7.2 Reactor Protection (Trip) System (RPS)—Instrumentation and Controls

The information in this section of the reference ABWR DCD, including all subsections, tables and figures, is incorporated by reference with the following departures and supplements.

STD DEP T1 2.3-1 (Table 7.2-1, 7.2-2, Figures 7.2-2, 7.2-6, 7.2-9, 7.2-10)

STD DEP T1 3.4-1 (Figures 7.2-2, 7.2-9, 7.2-10)

Figure 7.2-2 Reactor Protection System Equipment Arrangement (From Sensors Through Trip Actuators)

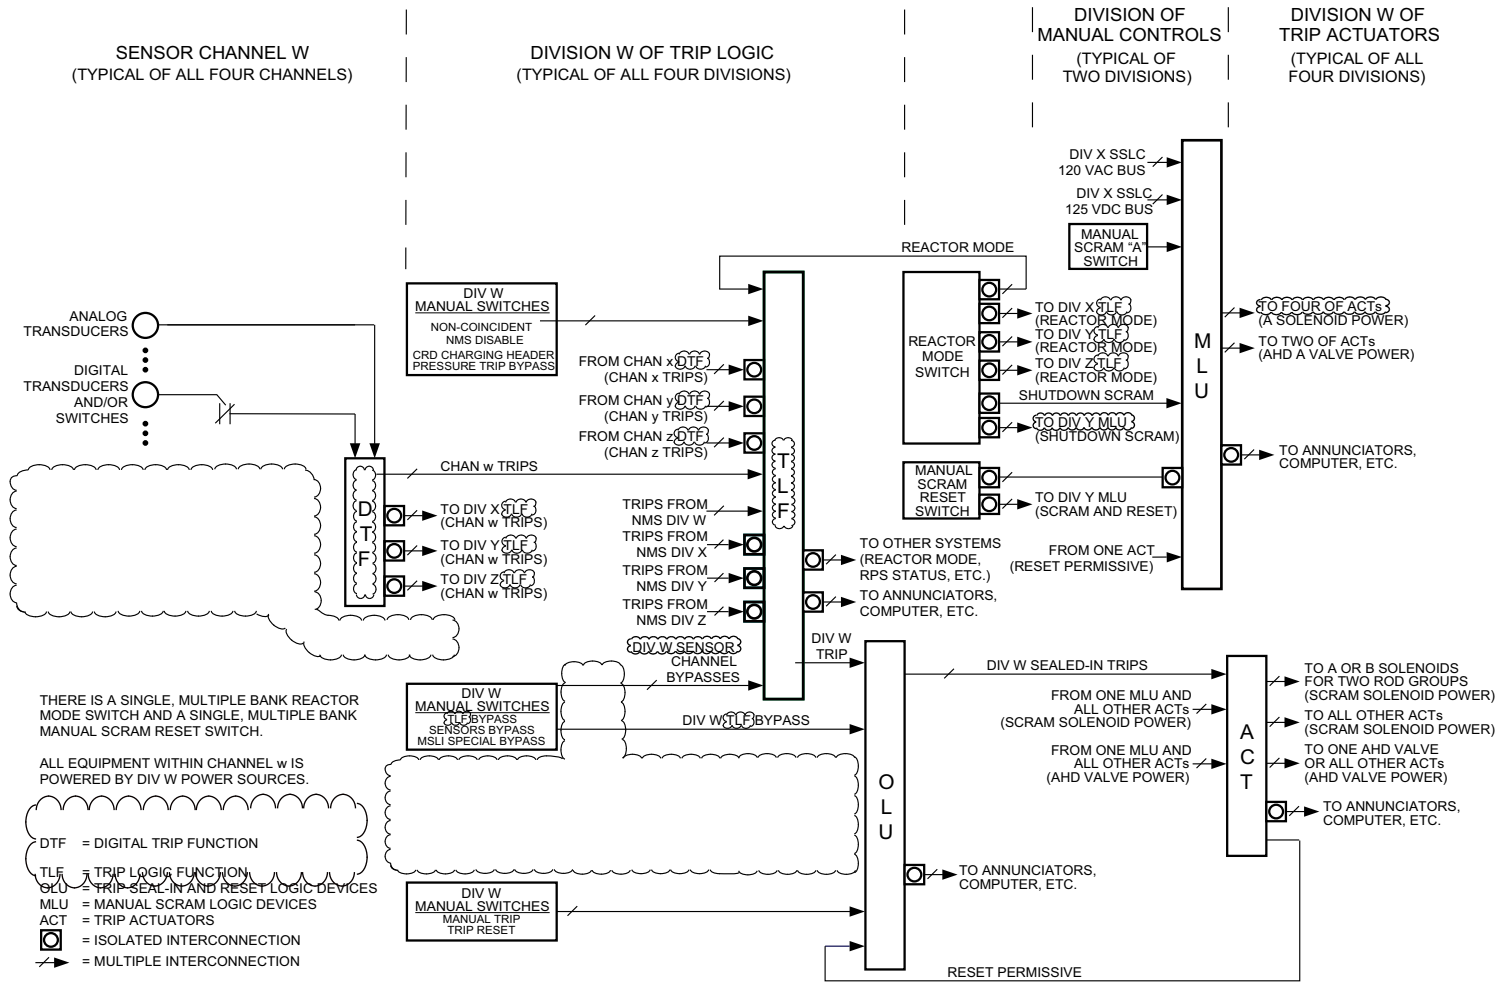
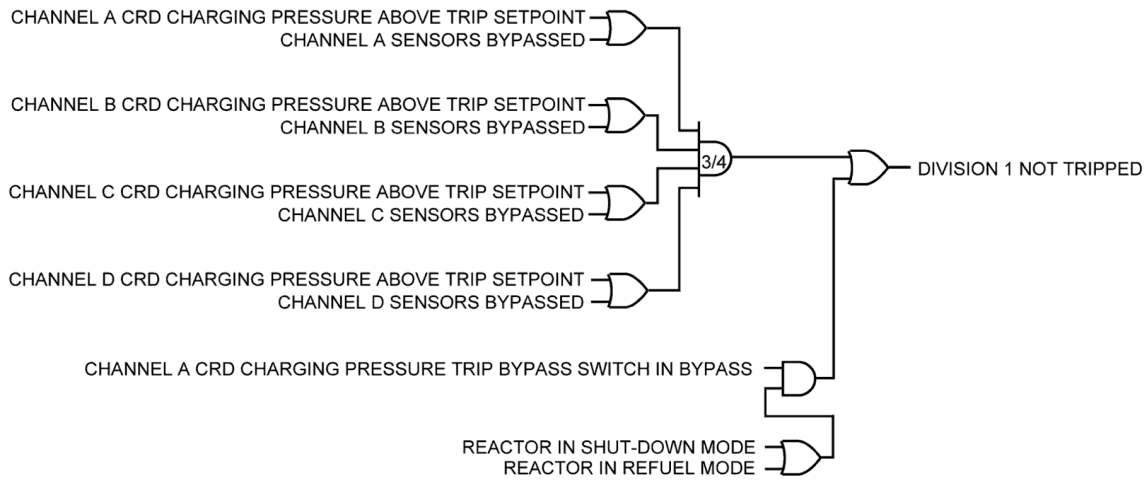
The RPS equipment is divided into four redundant divisions of sensor (instrument) channels, trip logics and trip actuators, and two divisions of manual scram controls and scram logic circuitry. The sensor channels, divisions of trip logics, divisions of trip actuators and associated portions of the divisions of scram logic circuitry together constitute the RPS scram and air header dump (backup scram) automatic initiation logic. The divisions of manual scram controls and associated portions of the divisions of scram logic circuitry together constitute the RPS scram and air header dump manual initiation logic. The automatic and manual scram initiation logics are independent of each other. RPS equipment arrangement is shown in Figure 7.2-2.

Equipment within a sensor channel includes primarily sensors (transducers or switches), ~~multiplexers and digital trip modules (DTMs)~~ trip functions (DTFs). The sensors within each channel monitor plant variables (Subsection 7.2.1.1.4.2) ~~and send either analog or discrete output to remote multiplexer units (RMUs) within the associated division of Essential Multiplexing System (EMS) the DTF.~~ Each division of the EMS performs analog to digital conversion on analog signals and sends the digital or digitized analog output values of all monitored variables to the DTF within the associated RPS sensor channel. The ~~DTM DTF~~ in each sensor channel compares individual monitored variable values with trip setpoint values and for each variable sends a separate, discrete (trip/no trip) output signal to all four divisions of trip logics.

Four independent sensor channels monitor the various process variables listed in Subsection 7.2.1.1.4.2. The redundant sensor devices are separated so that no single failure can prevent a scram. The arrangement of RPS sensors mounted in local racks is shown in Figure 7.2-2. Locations for local RPS racks and panels are shown on the instrument location drawings provided in Section 1.7. ~~Divisional separation is also applied to the Essential Multiplexing System (EMS) D which provides data highways for the sensor input to the logic units. Physically separated cabinets are provided for the four scram logics. Fiber optic cable routing from remote multiplexing units (RMUs) remote digital logic controllers to control room equipment is shown in raceway plans provided by reference in Section 1.7.~~ The criteria for separation of sensing lines and sensors are discussed in Section 7.1.

Figure 7.2-6 Division 1 Trip Logic

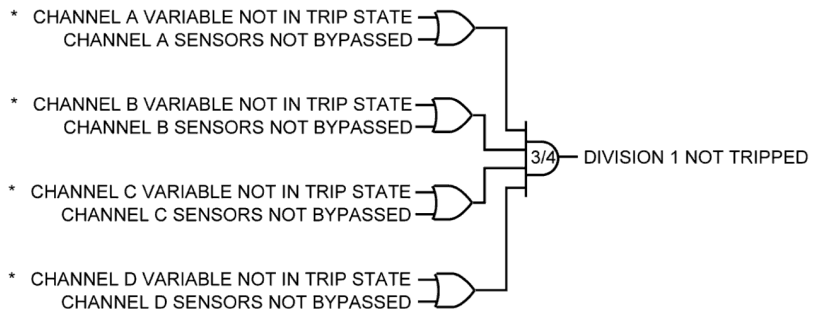
(2) Nuclear Boiler System (NBS) (Figure 7.2-6)

(4) ~~Process Radiation Monitoring (PRM) System (Figure 7.2-6)~~ Not Used

~~*High Main Steamline Radiation Trip (Figure 7.2-6)*~~

~~*A high main steamline radiation trip will occur in each division of trip logic when a main steamline radiation trip condition exists in any two or more unbypassed sensor channels. There are no operating bypasses associated with this trip function.*~~
